ADDENDUM NO. 2

NEW GYMNASIUM ADDITION TO MONTEVALLO HIGH SCHOOL

Architect Job No. 25-33

December 8, 2025

JOB NO.	25-33
SHEET NO:	P0.1

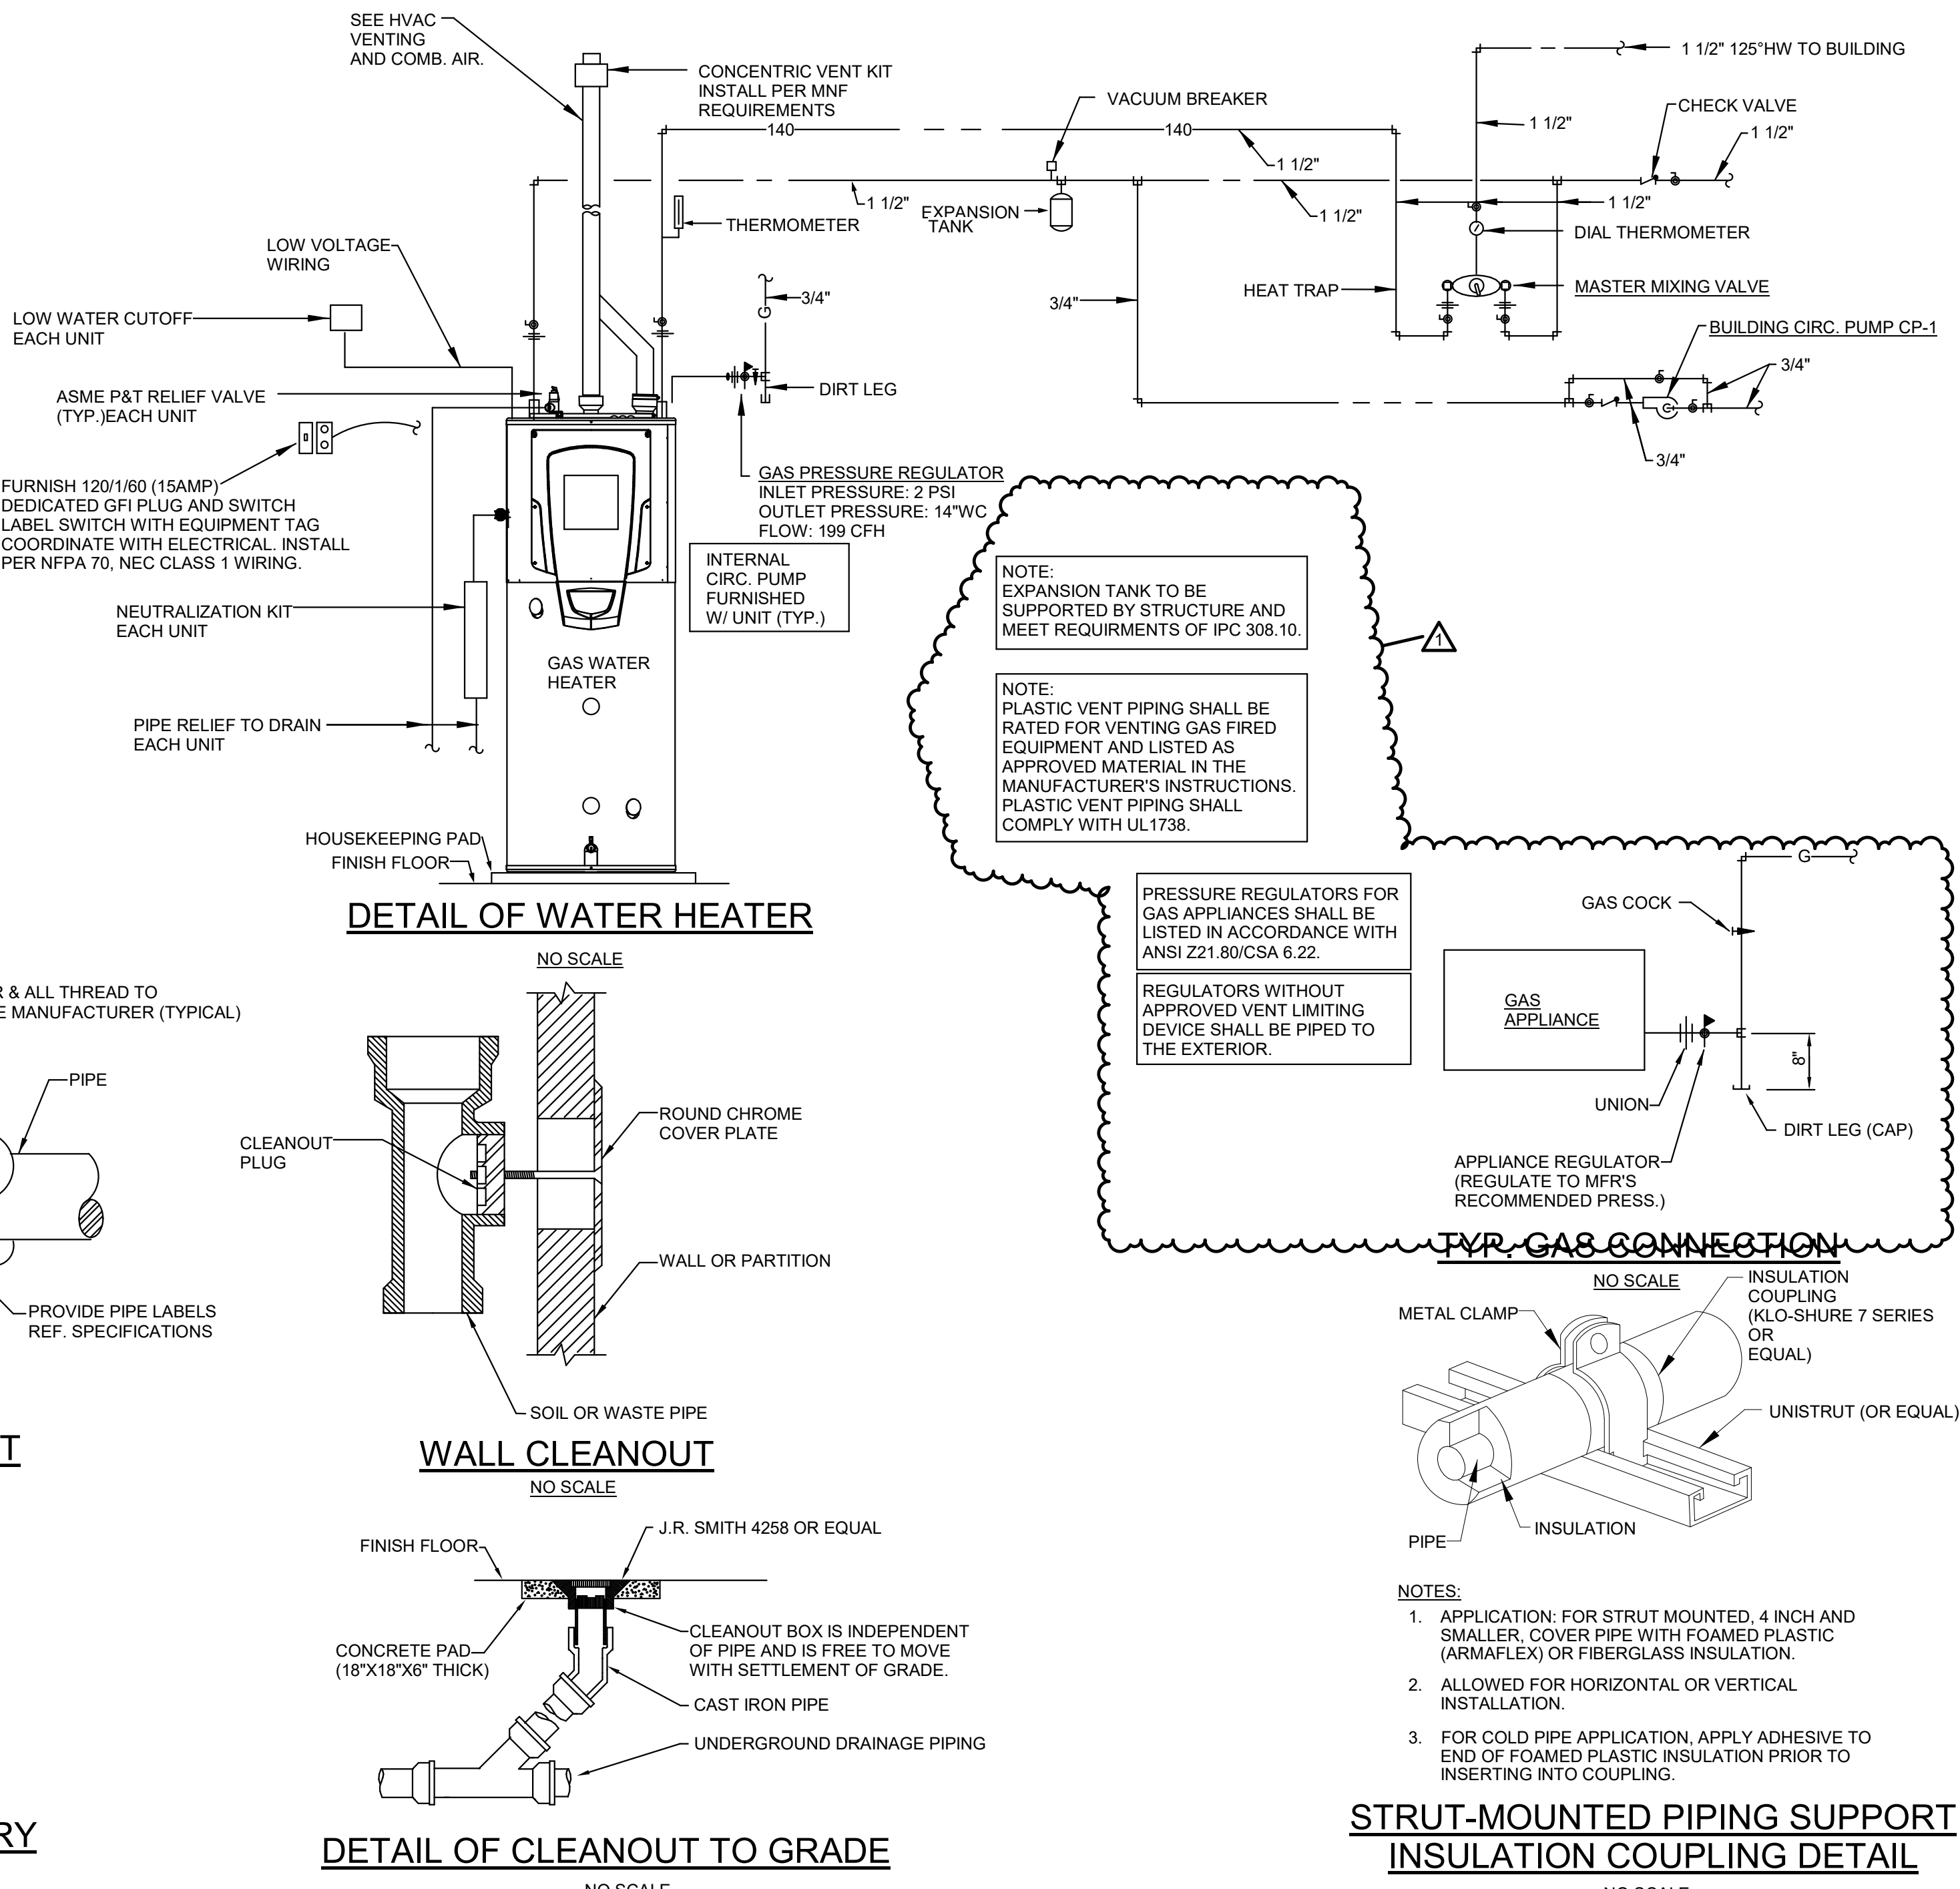
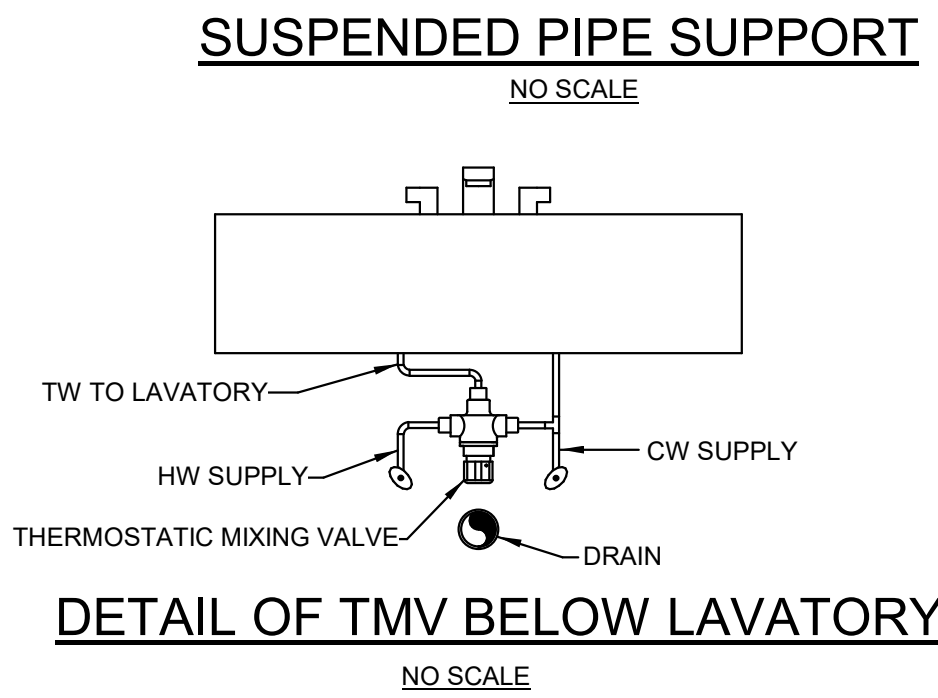
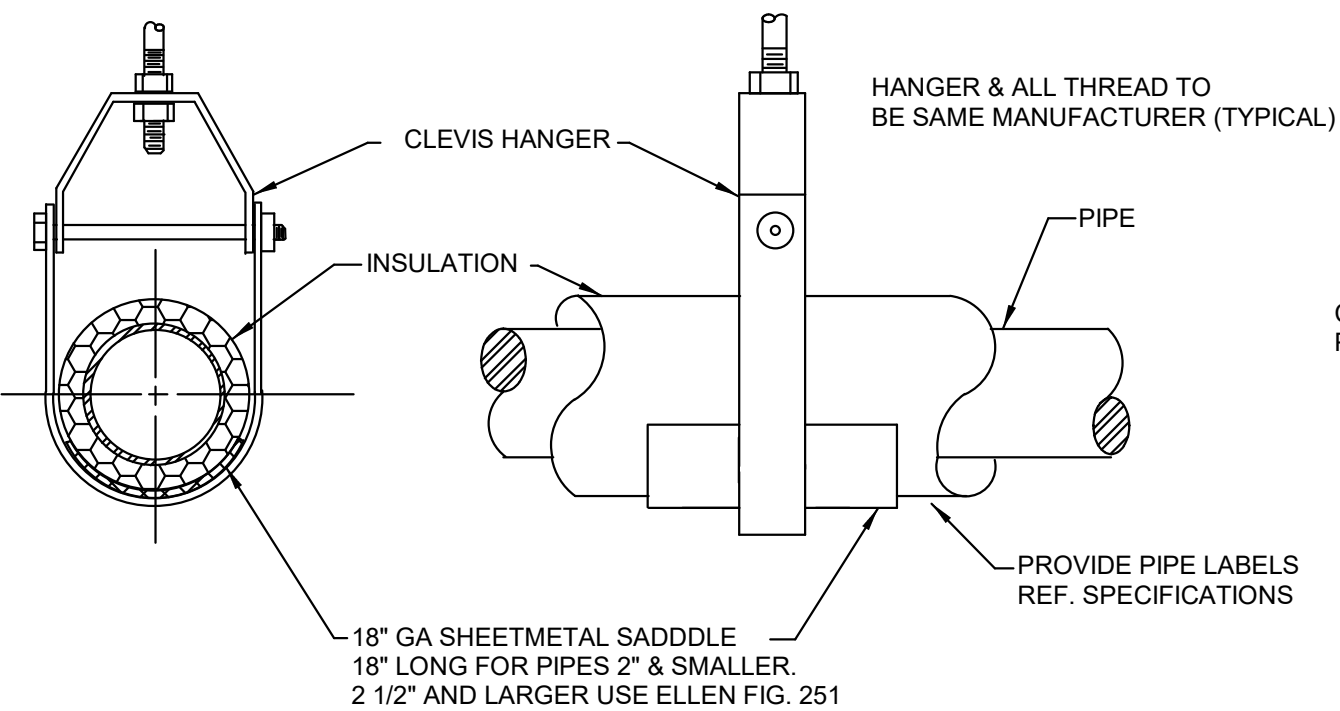
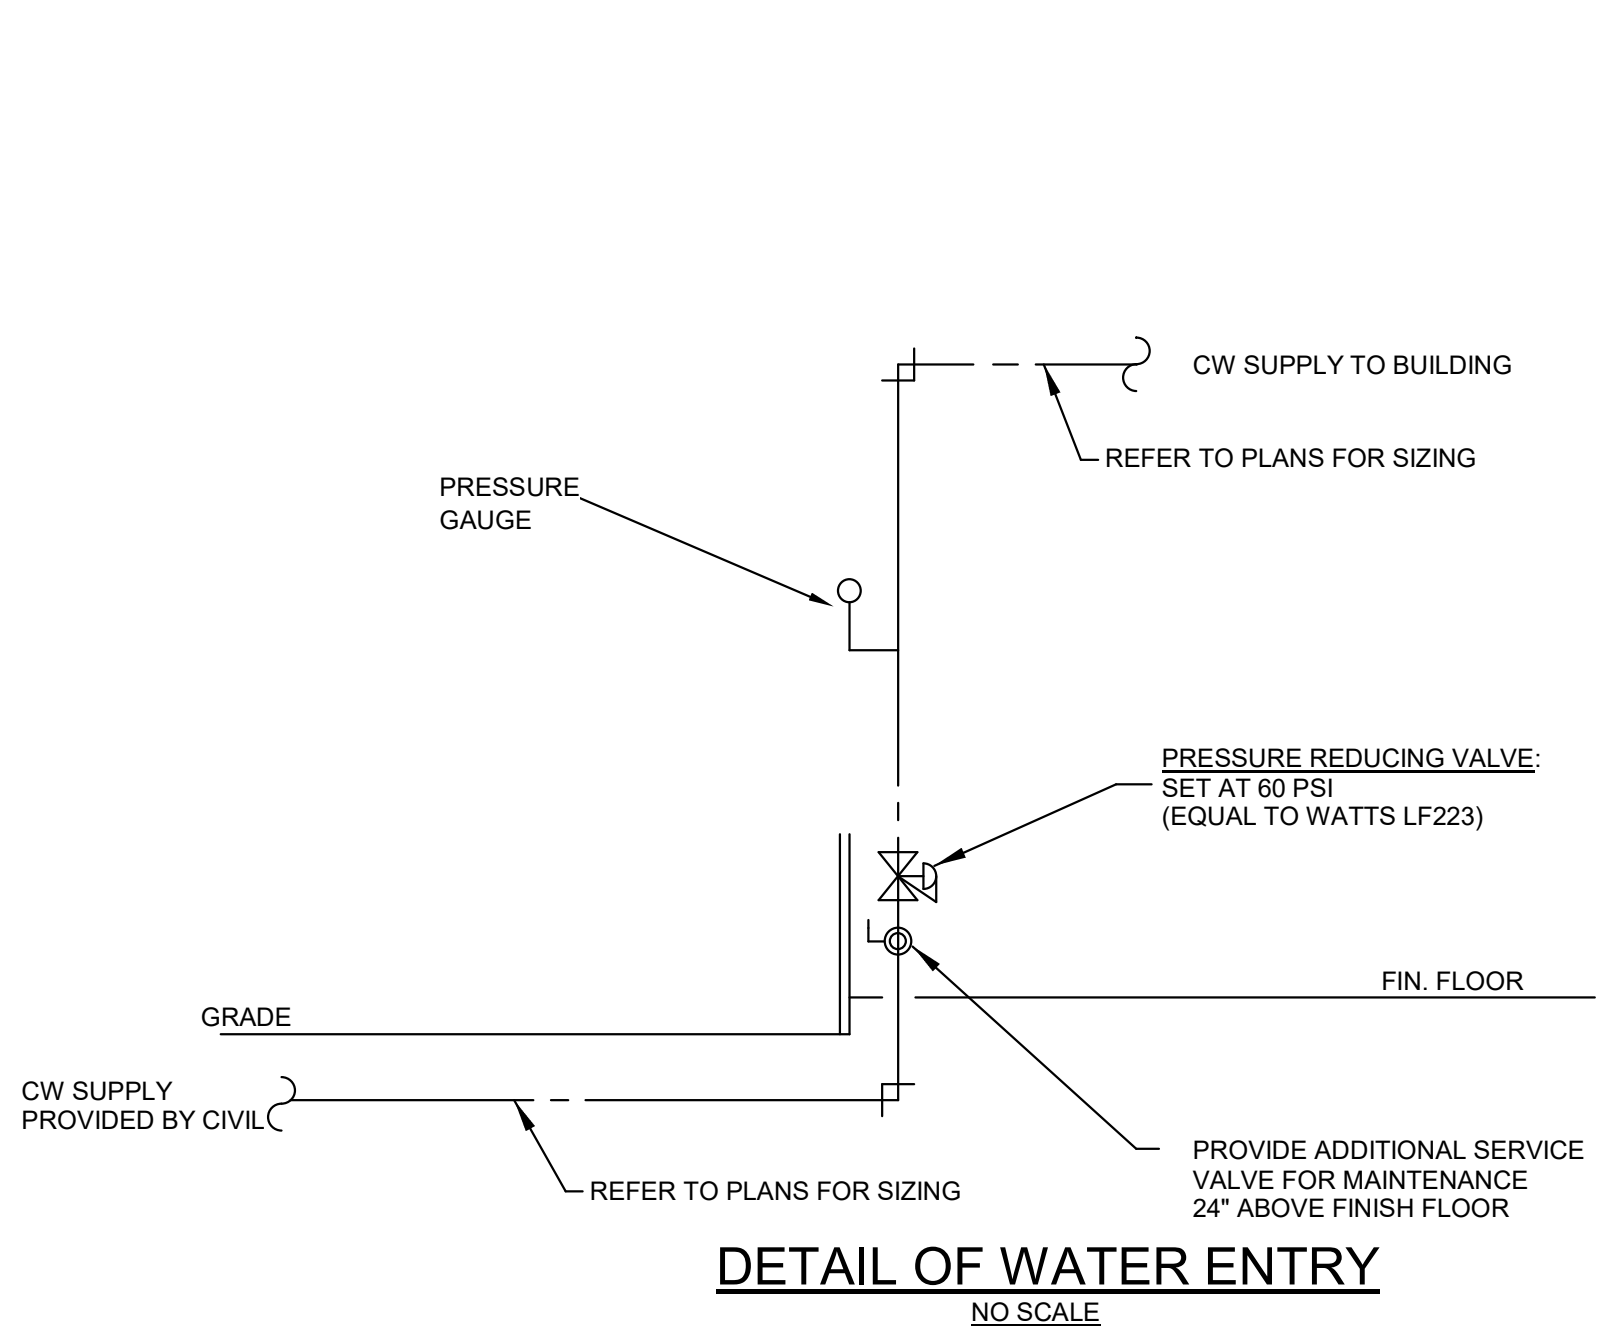
9. **Sheet FP1.0** – Revised sprinkler head locations.
10. **Sheet P0.1** – Revised washing machine specifications.
11. **Sheet P0.1** – Revised water heater and gas connection details.
